**To:** Dillan Murray, Assistant Planner, County of Ventura Resource Management Agency  
**via:** Mark Ross, Kevin Sheppard, Ashley James  
**From:** Mitch Stone, San Buenaventura Research Associates  
**Date:** 20 May 2022  
**Re:** Ojai Arts (2464 E. Ojai Avenue) Rehabilitation Plan Addendum

## Ojai Arts (2464 E. Ojai Avenue) Rehabilitation Plan

**Cultural Heritage: Application for Certificate of Review  
Fenestration Patterns**

# WEIST ESTATE DINING HALL

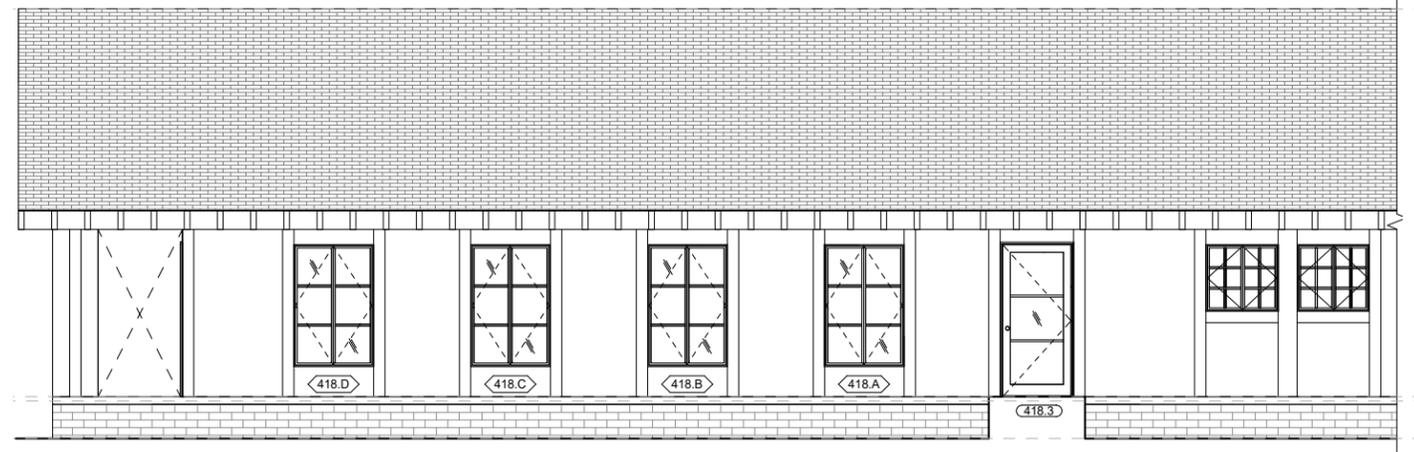
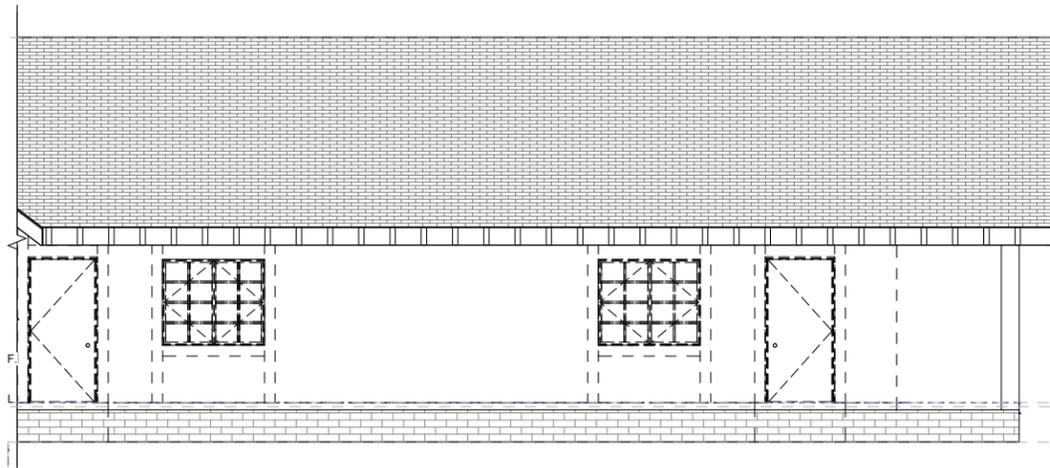
WEST - PROPOSED ELEVATION. OPENINGS TO COORDINATE WITH LOCATION OF DOOR AND WINDOW ROUGH OPENINGS REVEALED IN EXPOSED FRAMING

FRAMING LOCATION OF DOOR AND WINDOW ROUGH OPENINGS REVEALED IN EXPOSED FRAMING

2021 CONDITION

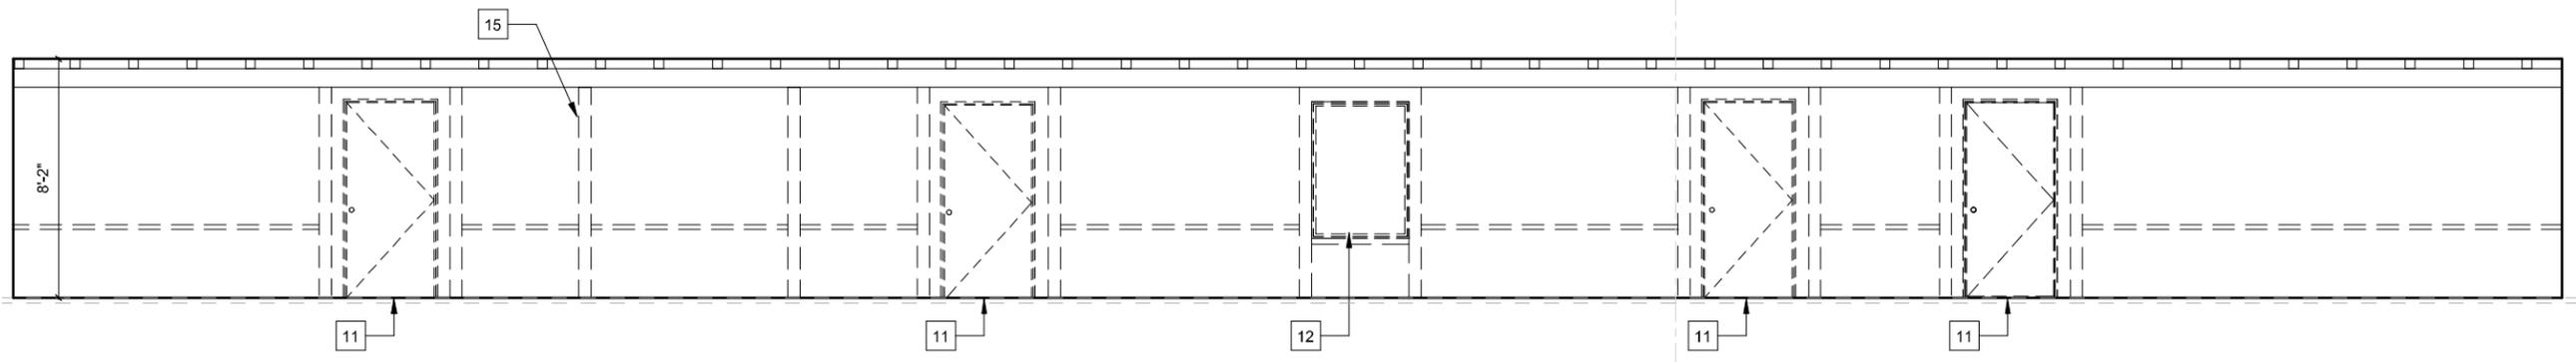
DOOR AND WINDOW UNITS SHOWN IN 2021 CONDITION PHOTOS WERE NONHISTORIC FIBERGLASS AND ALUMINUM UNITS.

LIVING UNIT DOORS - PROPOSED

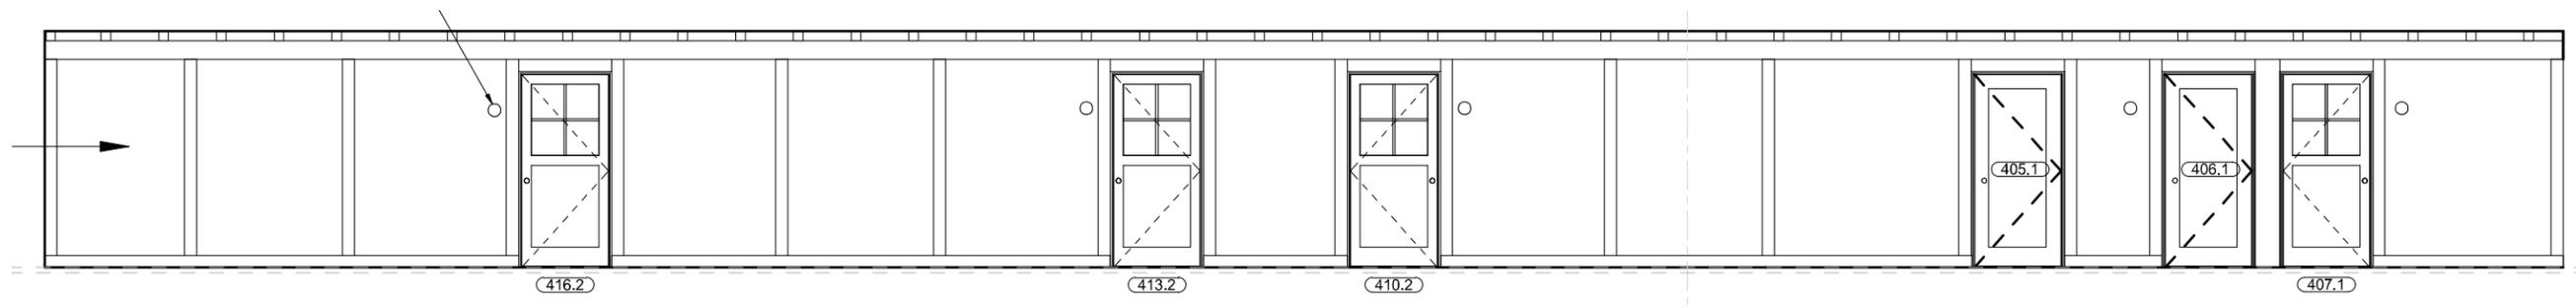
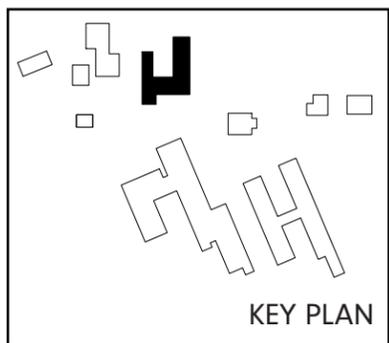
DOOR LOCATIONS ADJUSTED TO BETTER SERVE THE FUNCTION OF THE UPDATED INTERIOR LAYOUT AND PROVIDE ACCESSIBLE ROUTE TO ADA UNIT. DOOR UNITS SHOWN IN 2021 CONDITION PHOTOS WERE NONHISTORIC FIBERGLASS AND ALUMINUM UNITS. ORIGINAL EXTERIOR COVERED PORCH TO BE RESTORED AND NONHISTORIC WINDOWS REMOVED.

EAST - PROPOSED

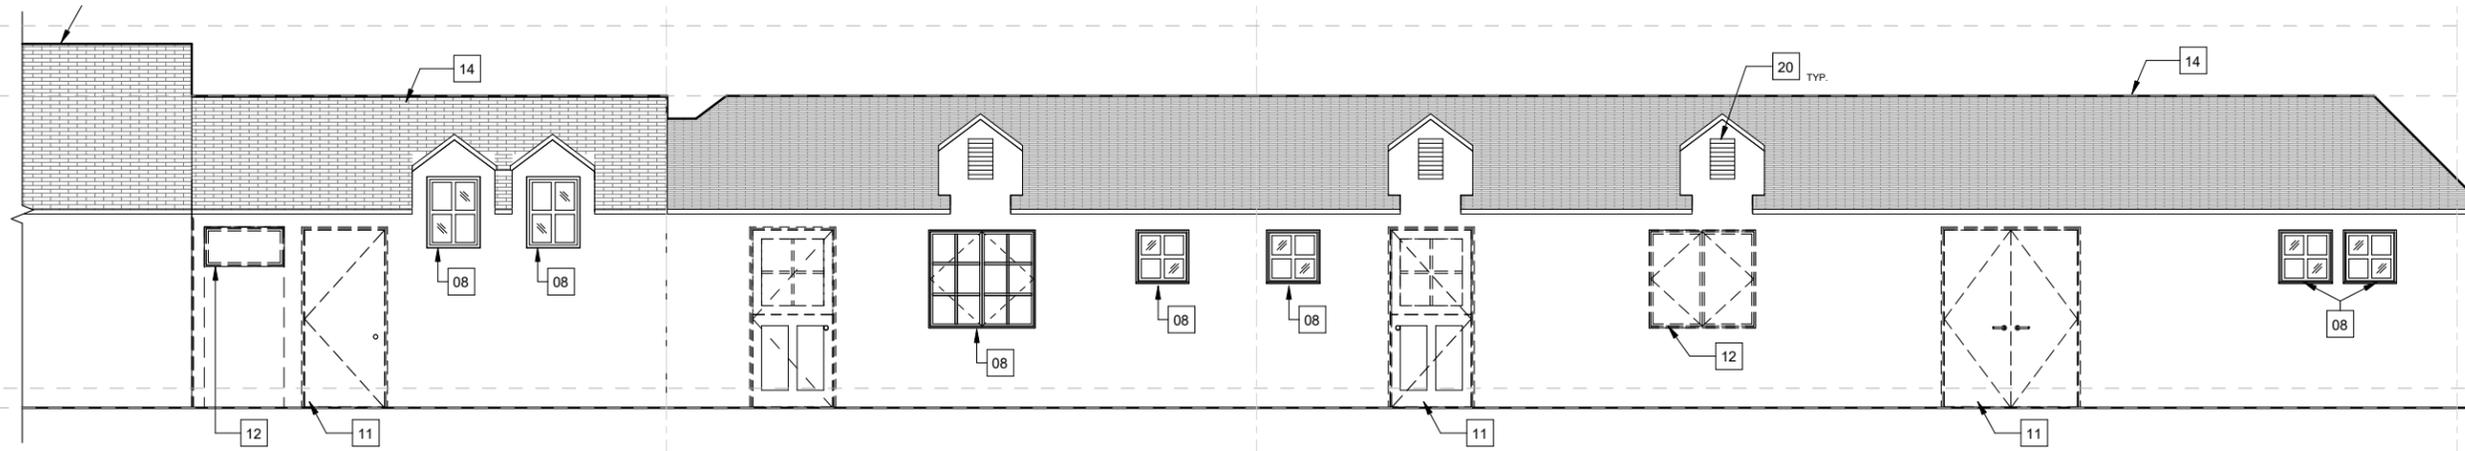
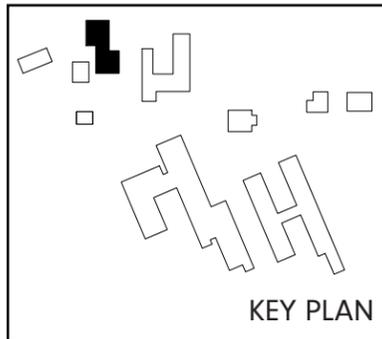
DOOR LOCATIONS ADJUSTED TO BETTER SERVE THE FUNCTION OF THE UPDATED INTERIOR LAYOUT AND PROVIDE ACCESSIBLE ROUTE TO LAUNDRY. UNITS AT ADJUSTED FENESTRATIONS DETAILED TO MATCH INTACT HISTORIC UNITS.

2021 CONDITION\_SOUTH-WEST

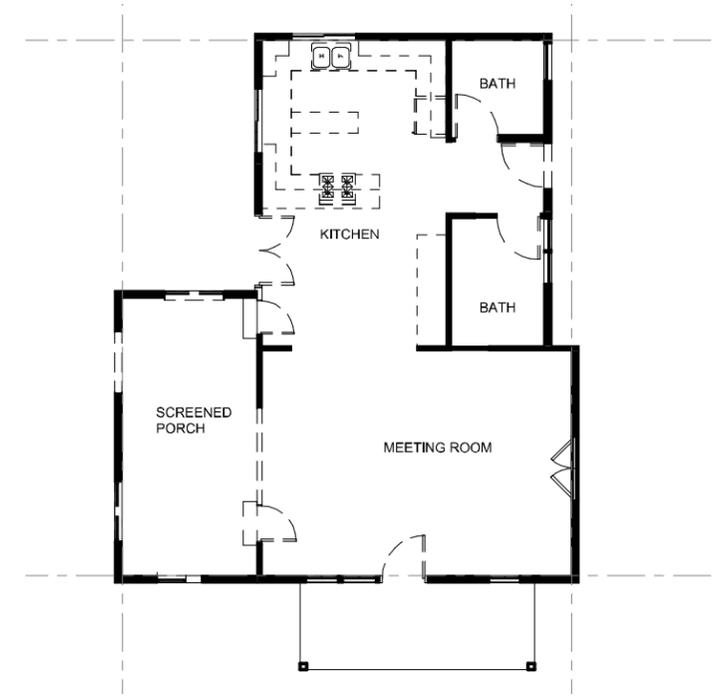
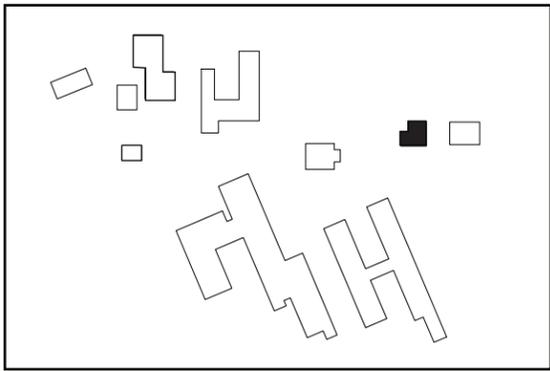
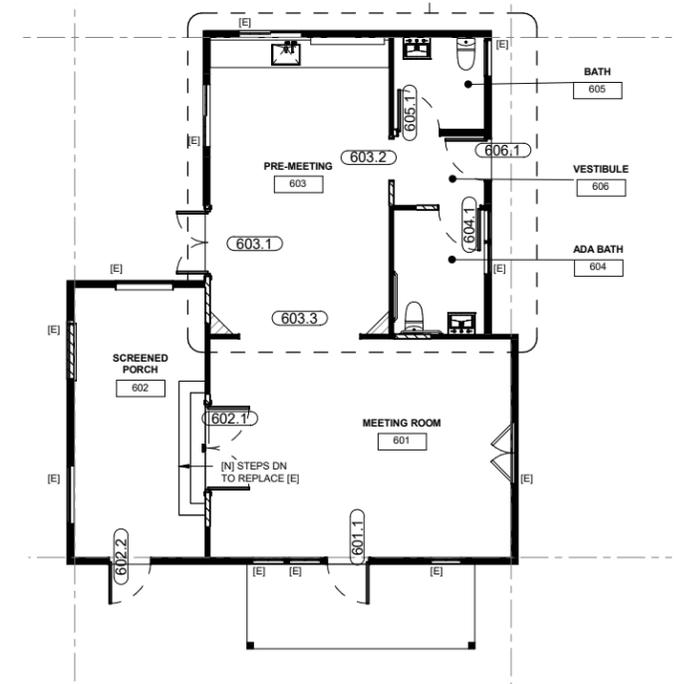
ALL FENESTRATIONS ARE EXISTING TO REMAIN. DOOR 602.2 HAS BEEN ADDED TO THE SCREENED PORCH IN ORDER TO CREATE A STEP FREE EGRESS.

2021 CONDITION\_NORTH-WEST

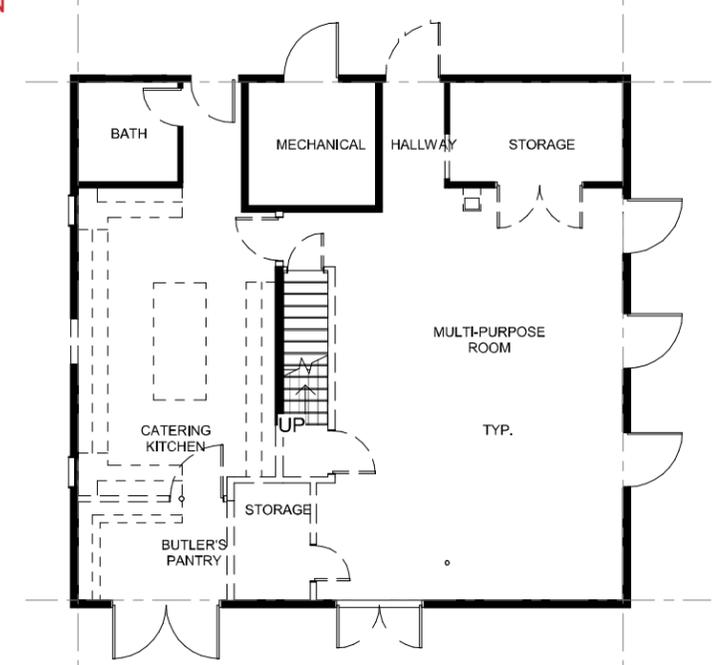
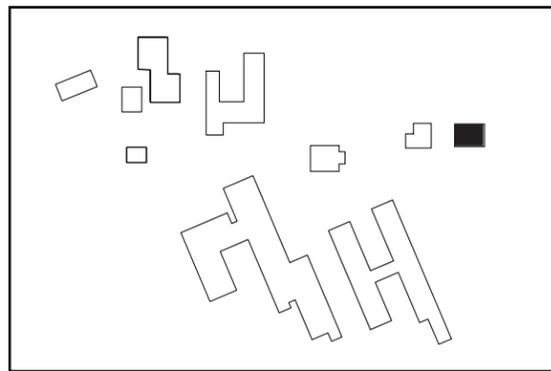
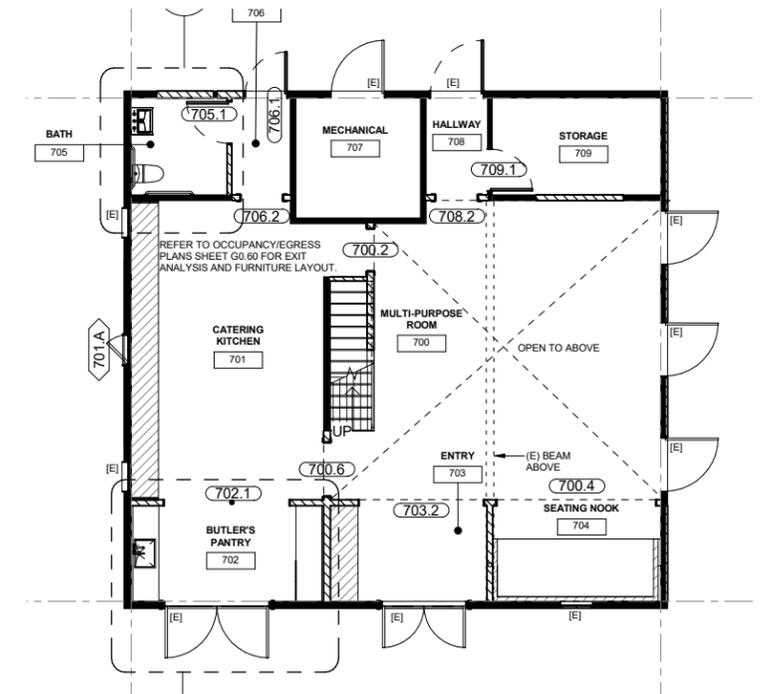
ALL OPENINGS ARE EXISTING TO REMAIN WITH THE EXCEPTION OF (1) WINDOW. UNIT 701.A IS A SINGLE ORIGINAL WOOD WINDOW TO BE REINSTALLED AT EAST ELEVATION DURING RENOVATION

PROPOSED PLAN\_NTS

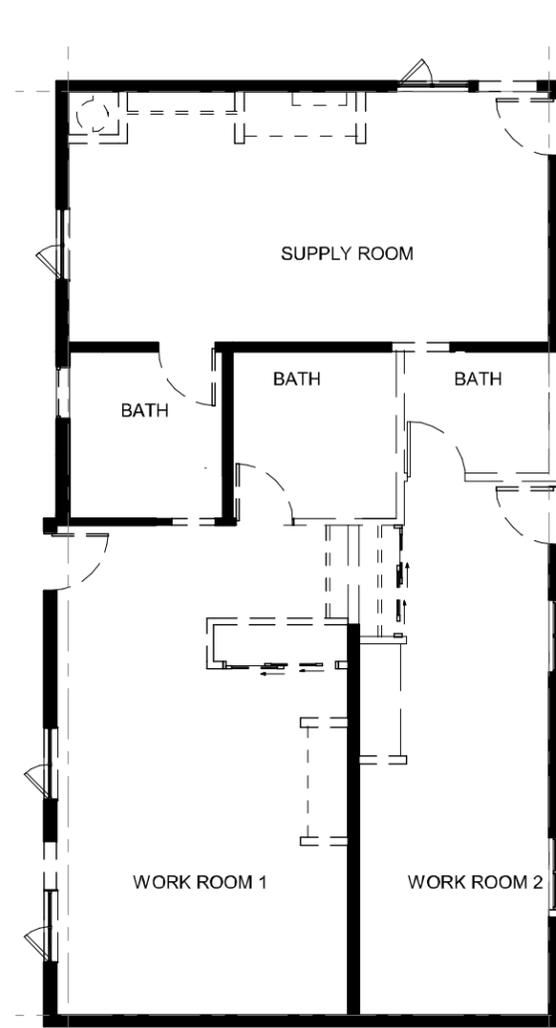
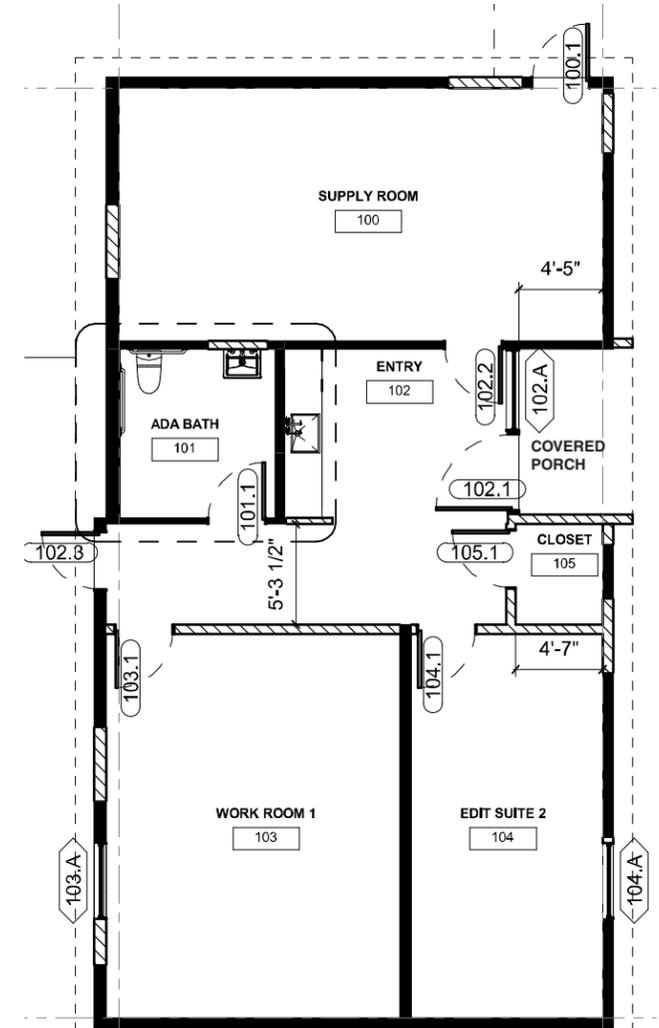
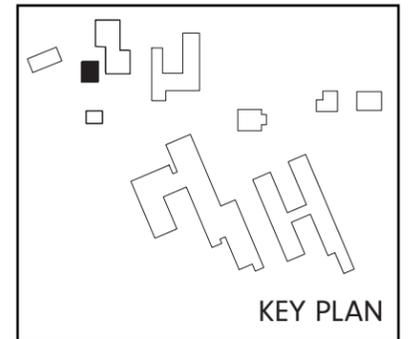
FENESTRATION CHANGES WERE MADE TO BETTER SERVE THE FUNCTION OF THE UPDATED INTERIOR LAYOUT. DOOR AND WINDOW UNITS SHOWN IN 2021 CONDITION PHOTOS WERE NONHISTORIC FIBERGLASS AND ALUMINUM UNITS.
